# **270 and 280 Casa Grande Road Creekwood Housing Development Project**

## **Final Environmental Impact Report**

Prepared for  
The City of Petaluma  
Community Development Department

**December 2024**

Figure 2-1  
Conceptual Northerly Off-Site Bridge Alternative

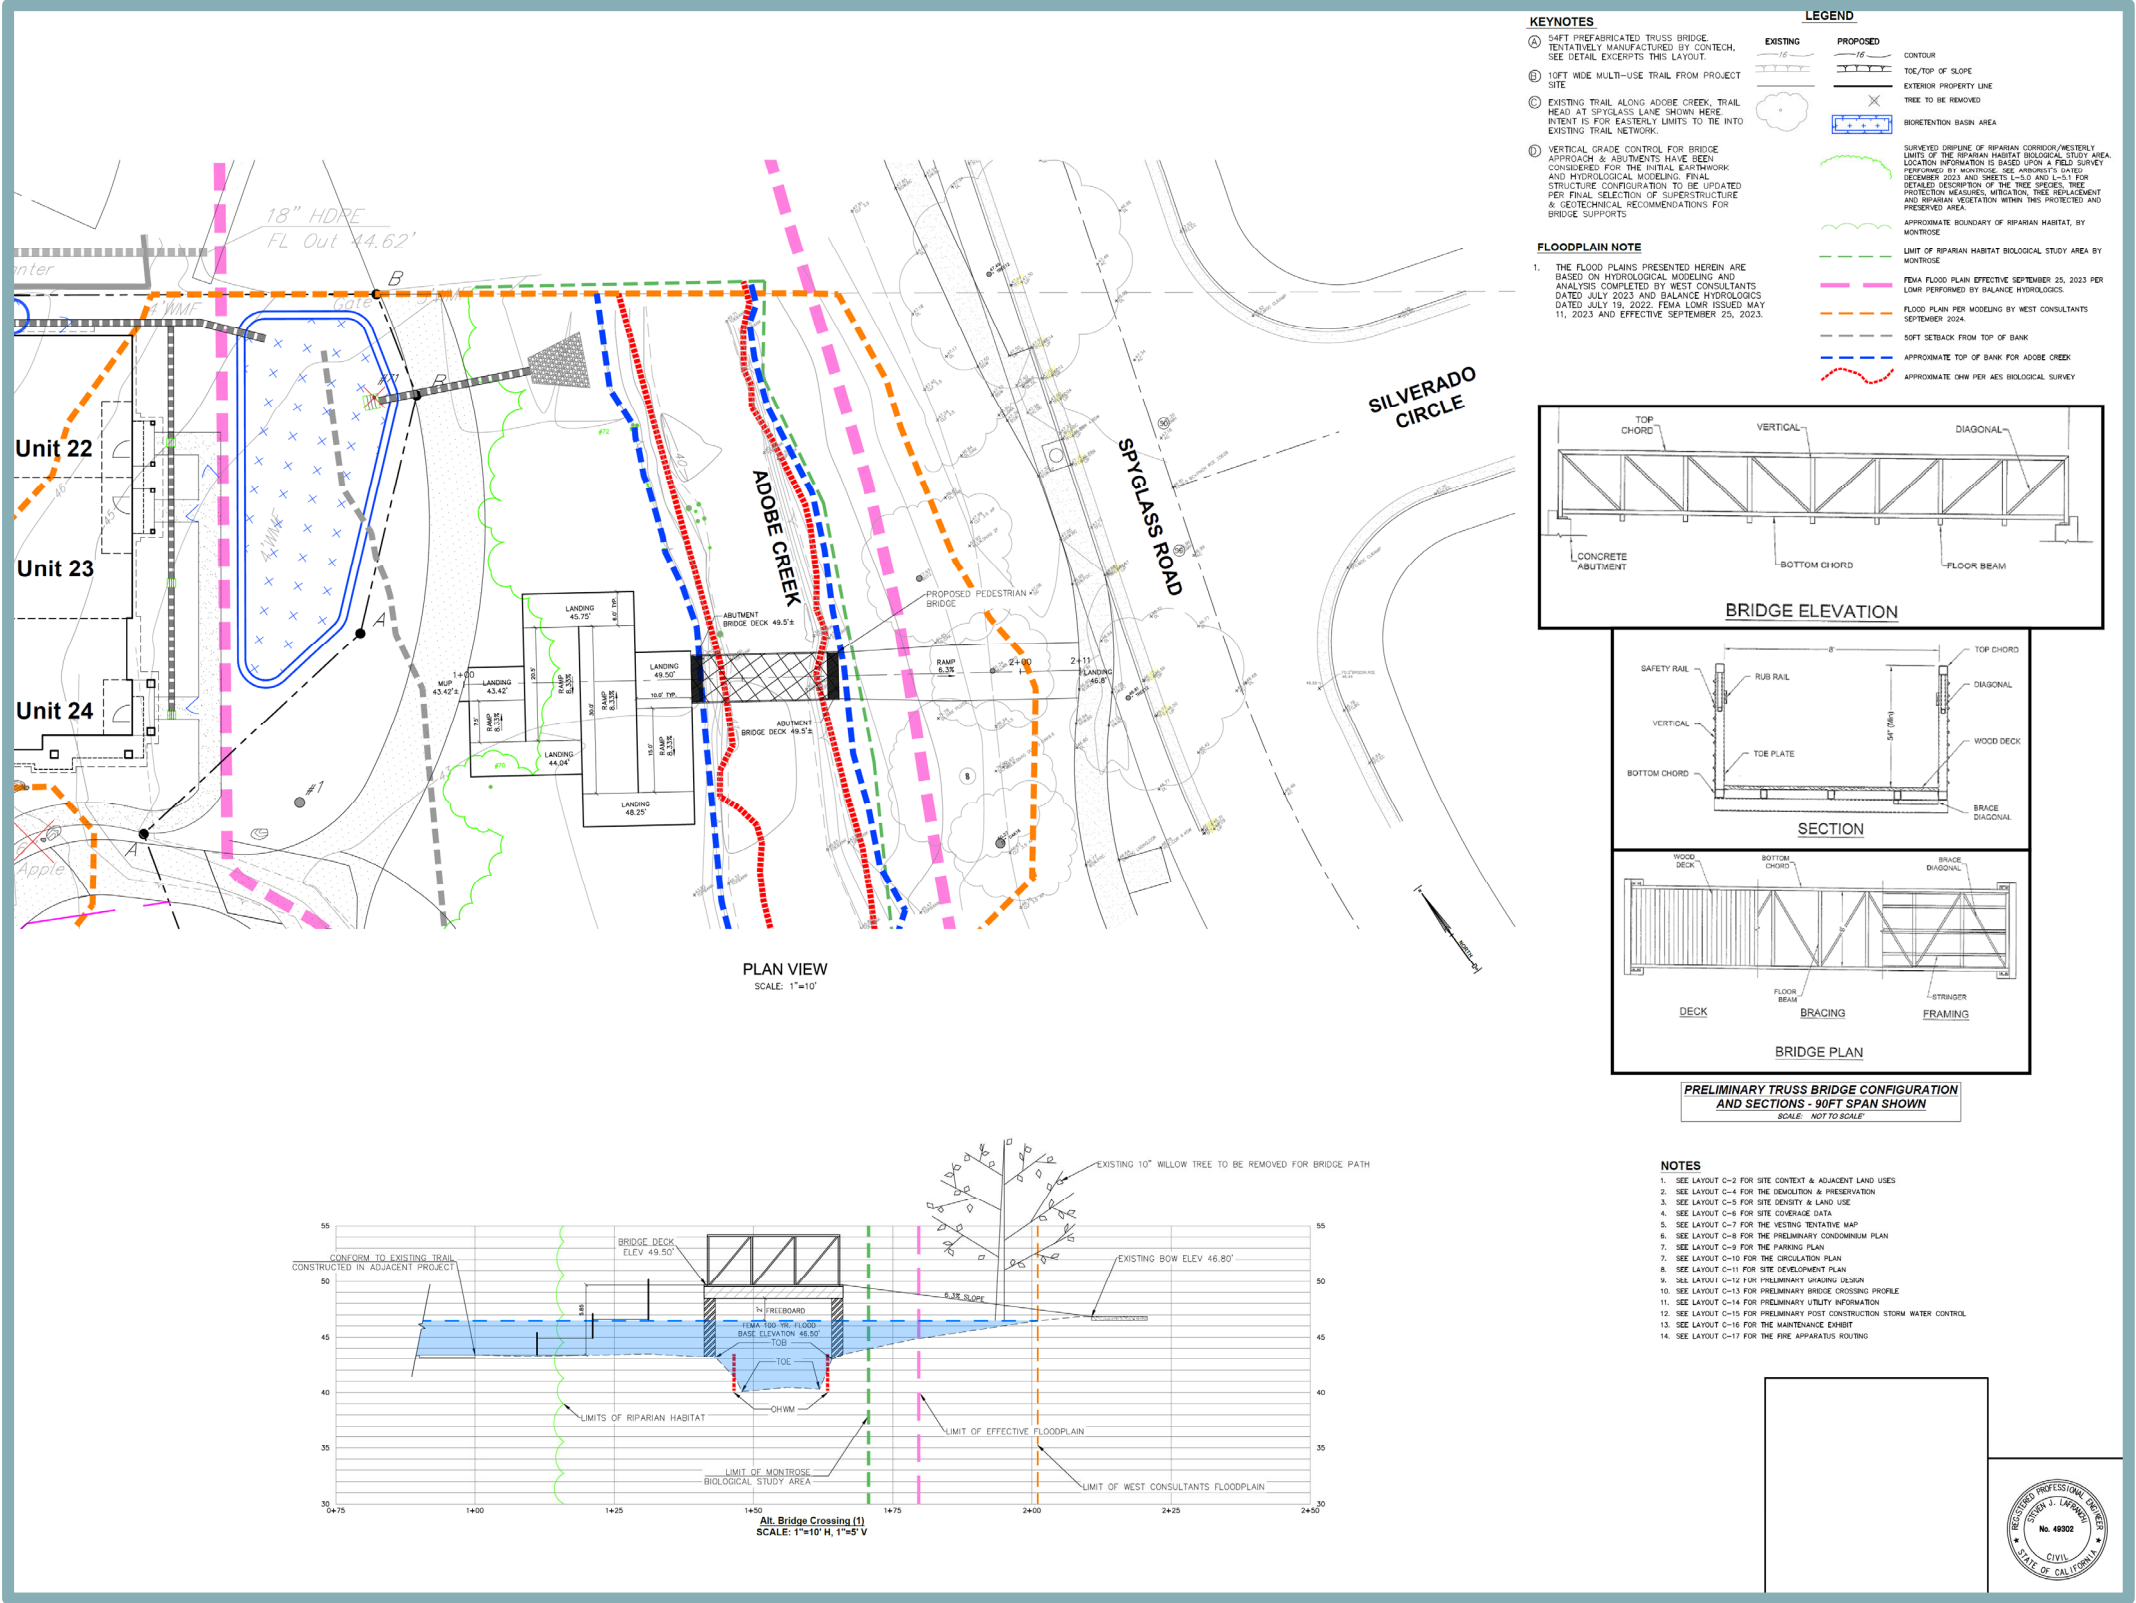
Several commenters recommended that alternative alignments for the proposed bridge be considered. This response will first identify why the currently proposed location was selected. The proposed bridge location was selected by the project applicant for several reasons, such as the level grade of the landing areas on both sides of the Creek; proximity to the Makenna public path and being the geographical center between Sartori Drive and Ely Road; the bridge abutments would be located outside the effective floodway boundary and not adversely affect the upstream or downstream water surface elevations or floodplain.

In response to the public comments, additional consideration was given to the suggested northerly alignment for the bridge, as shown in Figure 2-1. In this alternative location, the bridge would consist of a 54-foot-long prefabricated truss bridge that would connect to the proposed off-site multi-use pathway to the east of Adobe Creek and the existing path along Spyglass Road. The 54-foot-long truss bridge would be 36 feet less than the length of the proposed off-site bridge connection, which would consist of a 90-foot truss bridge. Due, in part, to its shorter alignment length, the northerly Off-Site Bridge alignment would require less removal of protected trees than the proposed project. In addition, the alternative bridge alignment would be located further from the existing private properties to the east of Adobe Creek.

However, whereas the proposed project would require a west approach elevation of 47.02 feet and an east approach elevation of 47.59 feet, the northerly Off-Site Bridge alignment would have a much greater grade difference that would require increased grading and the placement of fill within the Adobe Creek floodplain and riparian corridor. The following summarizes the challenges associated with the grade difference of a northly bridge alignment:

- Bridge Deck - The minimum freeboard (clearance) between the 100-year water surface base flood elevation and the bottom of the bridge deck (with the structural section of the bridge) must be 49.6 feet.

- **Spyglass Road Approach** - The elevation of the sidewalk on Spyglass Road is 46.8 feet. The elevation difference between the sidewalk and bridge deck is 2.8 feet. The distance between the sidewalk and the bridge is approximately 28.5 feet, creating an approach ramp with a slope of approximately 10%, and would require handrails on the ramp.

Ultimately, there are environmental trade-offs for the proposed bridge location and the northly bridge alignment shown in Figure 2-1. Whereas the proposed bridge location would minimize fill within the Adobe Creek corridor, as compared to the northerly alignment, the northly alignment is expected to require removal of fewer trees.

Existing conditions (facing northbound; school to left and project site to right)

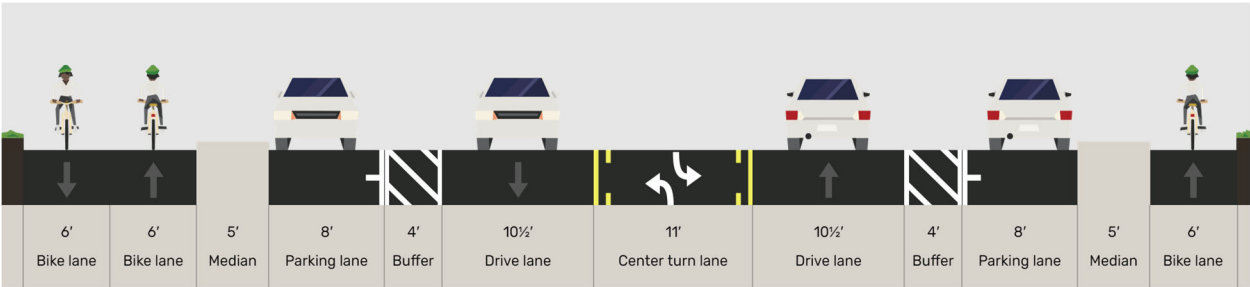
The City received several comments expressing concerns over potential traffic increases generated by the proposed project along Casa Grande Road and how said increases could affect safety along Casa Grande Road, particularly during pick-up and drop-off times associated with Casa Grande High School, which is located west of the project site, across Casa Grande Road. The consideration of a proposed development's potential to substantially increase traffic hazards due to a dangerous geometric design (e.g., sharp curves or dangerous intersections) or incompatible uses (e.g., farm equipment) is a question required for analysis under CEQA (see question 'c' of Section XVII, Transportation, of CEQA Guidelines Appendix G). In accordance with the foregoing requirements, the Draft EIR evaluates the potential for the proposed project to substantially increase hazards to vehicle safety under Impact 4.4-4, which starts on page 4.4-23.

The cross-sections below illustrate what could be possible through reducing and narrowing vehicle lanes and reallocating that roadway width to other uses, such as on-street parking and protected bike lanes. These are for illustrative purposes only and not intended to convey an official design proposal by the City.

As shown above, PW&U anticipates that the reconfigured Casa Grande Road would feature on-street parking lanes in each direction, which would be separated from the modified vehicle-travel

lanes by a four-foot-wide buffer, and protected Class IV bike lanes in both directions, which would be separated from the planned on-street parking lanes by five-foot-wide medians. The addition of protected Class IV bike lanes in both directions would meet the National Association of City Transportation Officials' guidance for bikeways that are safe and appealing to people of all ages and ability levels, consistent with the City's Draft Active Transportation Plan. The addition of on-street parking would also provide a physical barrier separating pedestrians along the road's sidewalks and help meet the neighborhood's growing parking needs. Additionally, the City anticipates the lane reduction to reduce speeding, weaving, and other dangerous driving behavior that is more likely to occur on streets with multiple lanes in each direction.
